Date: October 02, 2008

Subject: *Track Imaging Cherenkov, TrICE Experiment Safety Review Report*

Experimental Safety Review for TrICE

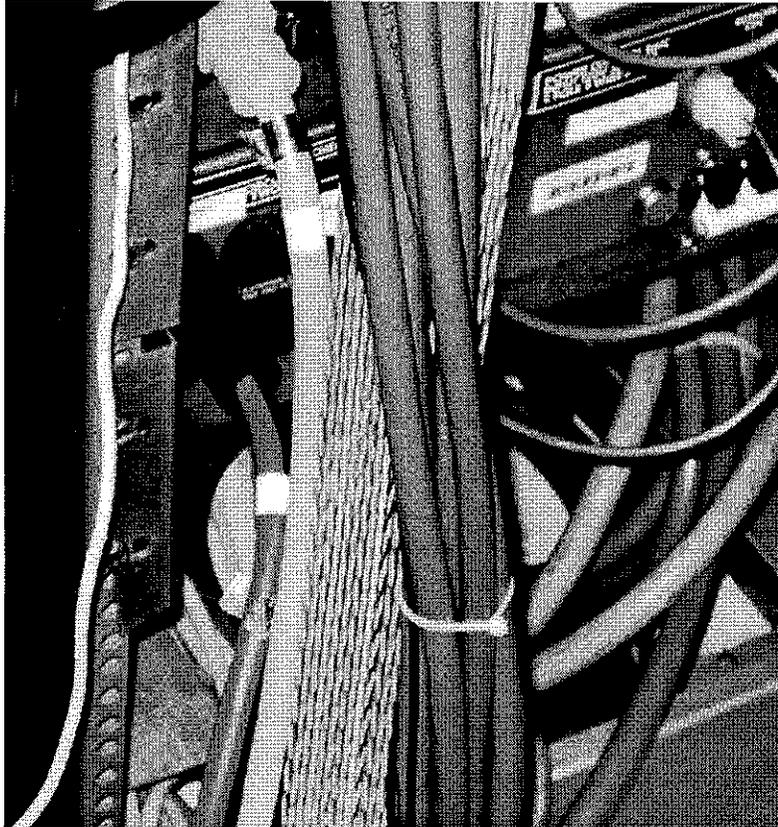
1. Rigid Nonmetallic Conduit (RNC)

a. Securing and Supporting requirements. NEC 352.30 (A) requires the conduit to be secured within 3 feet of each outlet box, junction box, device box, conduit body, or other conduit termination. The larger pipe's clean out needs support following this requirement.

b. Support of Rigid Nonmetallic Conduit. NEC table 352.30(B) requires ½-1 inch RNC to have a maximum spacing of 3 feet between supports, 1 ¼- 2 inch RNC have a maximum spacing of 5 feet between supports, 2 ½ - 3 inch RNC have a maximum spacing of 6 feet between supports and 3 ½ - 5 inch RNC have a maximum spacing of 7 feet between supports.

c. The plumbing pipe is not being used according to its listing. NEC 110.3(B) Installation and Use, requires that a product be installed per its listing requirements. I will as the day to day AHJ allow this installation due to the nature of the wiring.

d. Bushings. NEC 352.46 requires a bushing on a conduit to have a bushing installed to protect the wire from abrasion unless the box, fitting or enclosure provides equivalent protection.

e. Securing and Supporting. NEC 300.11(B) Raceways Used as Means of Support. The raceways can not support other raceways unless they are identified for that purpose. I recommend that a unistrut is staked to the ground and the pipes be secured to that unistrut. The pipes on top of one another need to be ran along side each other.

I suggest that the pipes be run along side of one another with a piece of unistrut underneath staked to the ground. Then the conduits need to be secured to the unistrut at the appropriate intervals.

Extension Cords enter Raceway to Tent

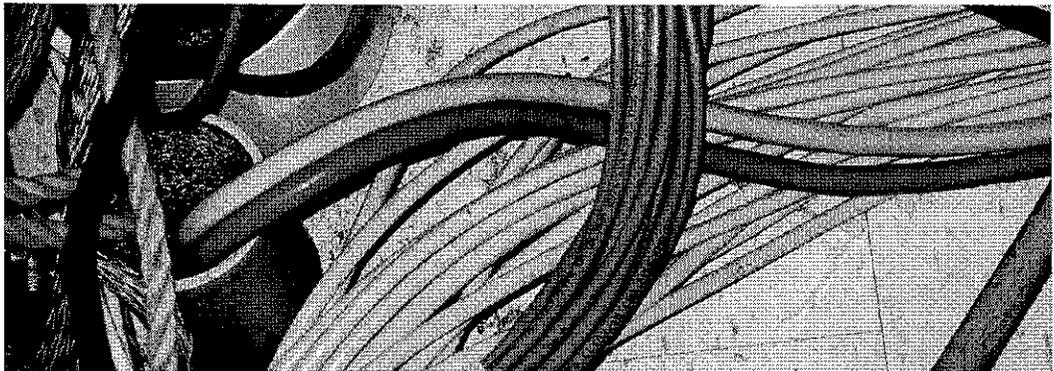
1. Extension cords
 - a. Extension cords are covered in the ES&H manual in section 9.3.4:
 - i. **90 Days.** Temporary electrical power and lighting installations will be permitted for a period not to exceed 90 days for holiday decorative lighting and similar purposes.

- iii. 400.14 **Protection from Damage** Flexible cords and cables shall be protected by bushings or fittings where passing through holes in covers, outlet boxes or similar enclosures. In industrial establishments where the conditions of maintenance and supervision ensure that only qualified persons service the installation, flexible cords and cables shall be permitted to be installed in aboveground raceways that are no longer than 15 m (50 ft) to protect the flexible cord or cable from physical damage.

- c. A case could be made for allowing extension cords as used in the TrICE trailer, as this is developmental work that requires frequent interchange. If allowed, the following changes are recommended:

- i. Bushings or fittings to protect the cords at the point they enter and leave the raceway to the telescope.
 - ii. Method of locking out the trailer end of the cords.

Liquidtight Flexible Metal Conduit

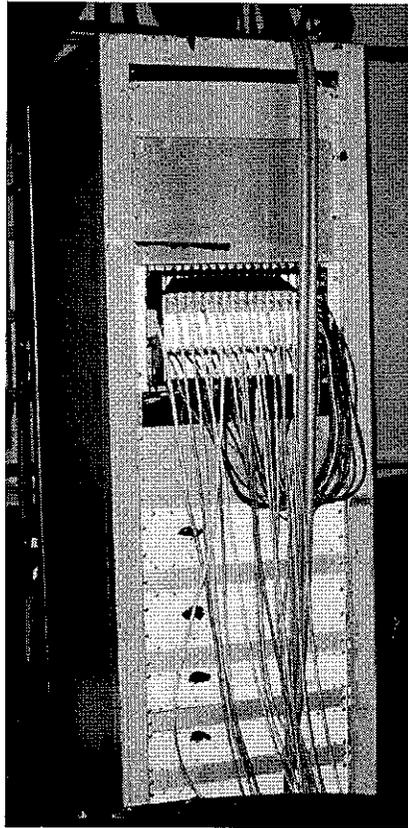
2. Liquidtight Flexible Metal Conduit, and attachment plug used to run power at the telescope.
 - a. Applicable section of the National Electrical Code, NFPA 70 2008 edition in Article 350, **Liquidtight Flexible Metal Conduit: Type LFMC (A) Securely Fastened.** LFMC shall be securely fastened in place by an approved means within 300 mm (12 in.) of each box,

cabinet, conduit body, or other conduit termination and shall be supported and secured at intervals not to exceed 1.4 m (4 1/2 ft). *Exception No. 2:* Where flexibility is necessary after installation, lengths shall not exceed the following: (1) 900 mm (3 ft) for metric designators 16 through 35 (trade sizes ½ through 1 ¼).

- i. The LFMC should be secured according to the section of the NEC copied above.
 - ii. Since the attachment plug was not intended to be used with LFMC it must be evaluated to ensure that makes a secure connection to the LFMC to prevent it from being accidentally pulled loose and exposing energized conductors.

Attachment Plug on LFMC

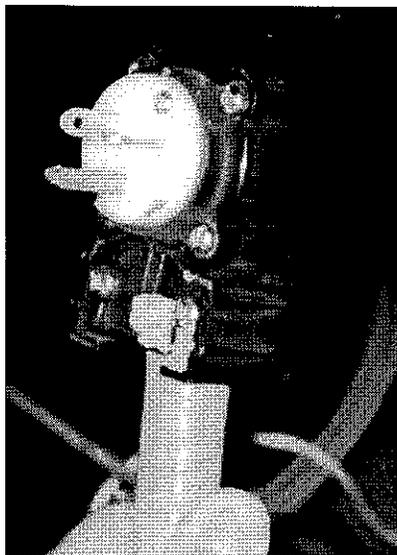
- b. The attachment plug used is not listed for use with LFMC.
 - c. Again, a case could be made for allowing this wiring method as necessary to prevent rodent damage to energized conductors. If allowed the following is recommended.
